UNITED STATES PATENT AND TRADEMARK OFFICE

APPLICATION NO.	FILII	NG DATE	FIRST NAMED INVENTOR	ATTORNEY DOCKET NO.	CONFIRMATION NO.	
10/805,790	03/	/22/2004	Young-Churl Bang	5000-1-545	9942	
33942	7590	04/13/2006		EXAMINER		
CHA & RE			STARK, JARRETT J			
210 ROUTE 4 EAST STE 103 PARAMUS, NJ 07652				ART UNIT	PAPER NUMBER	
,				2823		
				DATE MAIL ED: 04/13/2006	DATE MAILED: 04/13/2006

Application No.	Applicant(s)					
	10/805,790	BANG ET AL.					
Office Action Summary	Examiner	Art Unit					
	Jarrett J. Stark	2823					
The MAILING DATE of this communication appears on the cover sheet with the correspondence address Period for Reply							
A SHORTENED STATUTORY PERIOD FOR REPLY WHICHEVER IS LONGER, FROM THE MAILING DA - Extensions of time may be available under the provisions of 37 CFR 1.13 after SIX (6) MONTHS from the mailing date of this communication. - If NO period for reply is specified above, the maximum statutory period w - Failure to reply within the set or extended period for reply will, by statute, Any reply received by the Office later than three months after the mailing earned patent term adjustment. See 37 CFR 1.704(b).	ATE OF THIS COMMUNICATION 36(a). In no event, ho

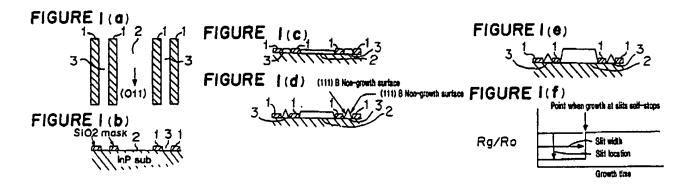
- (a) forming, a first mask pattern on a semiconductor substrate having a (100) crystalline plane, said first mask pattern having a first window wider than the selective area; (Itagaki, Col. 2 Lines 26-45 & Claim 1) **NOTE: Figures shown below show the mask alignment not the crystalline plane of the substrate which is (100)**

- (b) forming a second mask pattern having both a second window and a third window, the second window being defined by spacing of the second mask pattern from the first mask pattern, in correspondence with a blocking area for blocking the surface migration of a III-group semiconductor source gases at edges of the first window, and the third window being as wide as the selective area; and (<u>Itagaki</u> Figs. 1(a-f))

- (c) growing the semiconductor layer by MOCVD on the semiconductor substrate exposed by the second and third windows. (<u>Itagaki</u> Figs. 1(a-f) shown below)
